**TRAFFORD**  
**COUNCIL**

**Further Changes to Proposals Map and  
Key Diagram following October 2011  
consultation**

**31<sup>st</sup> October 2011**

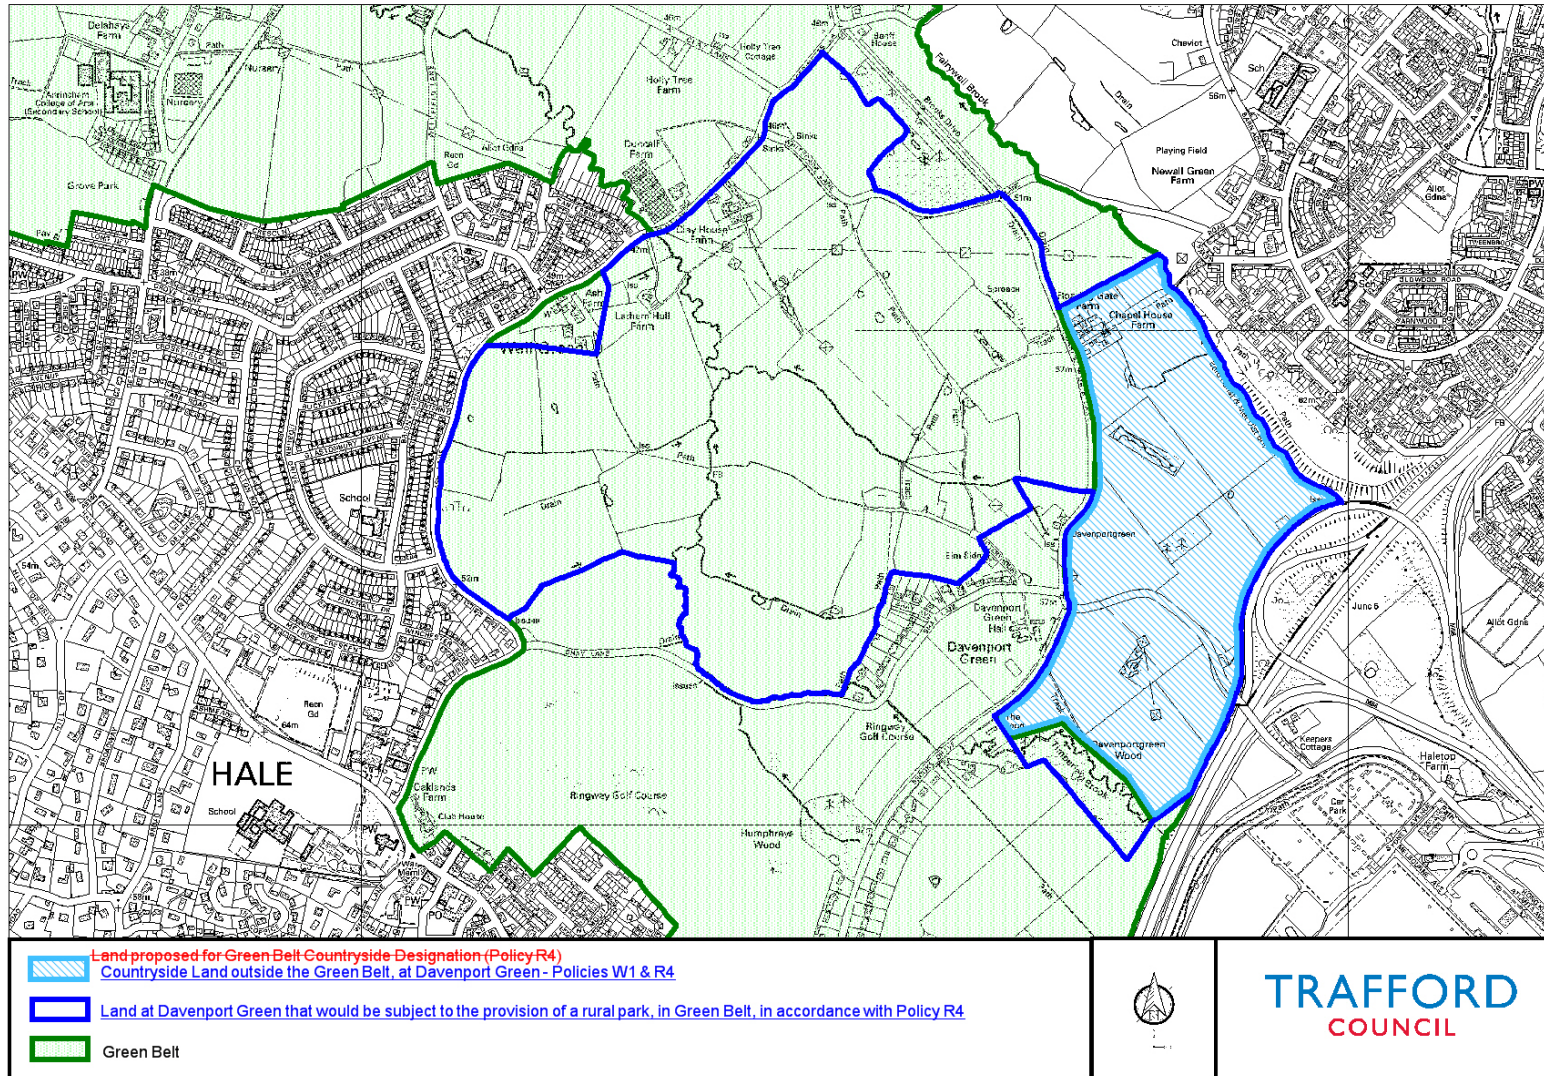
In response to the consultation, Royal London Asset Management submitted a representation (CD12.4.11) seeking a change to the Proposals Map as follows:

*"The plan is difficult to read by using pale green to denote Davenport Green. It is hard to distinguish from the Green Belt. Similarly, it should not be left white or a colour hardly distinguishable from white, so that it is clearly distinguished from the adjoining land which has no specific policy designation. We ask that pink is used to distinguish clearly the land from the Green Belt. Use of the same colour as the Key Diagram will be consistent and help to avoid confusion."*

The Council accepts that this clarification is necessary to make the Proposals Map colouring for Davenport Green clearer. However, it considers that blue would be a more appropriate colour as pink stripes could be confused with the UDP Policy ENV17 Protection of Landscape Character colouring and blue would also reflect the site's potential employment use. This would also require a consequent change to the Key Diagram to change the colour of the icon from pink to blue. The Council does not consider that the changes presented in this document would alter the overall thrust of the Council's policy position. It does not therefore consider that, should these further revisions to the Proposals Map and Key Diagram be accepted by the Inspector, there would be significant procedural implications.

These proposed changes will be added to the Schedule of Proposed Changes (CD 12.4) at S300.124 and S300.127 as appended to this document. These suggested changes supersede S300.118 and S300.119 respectively.
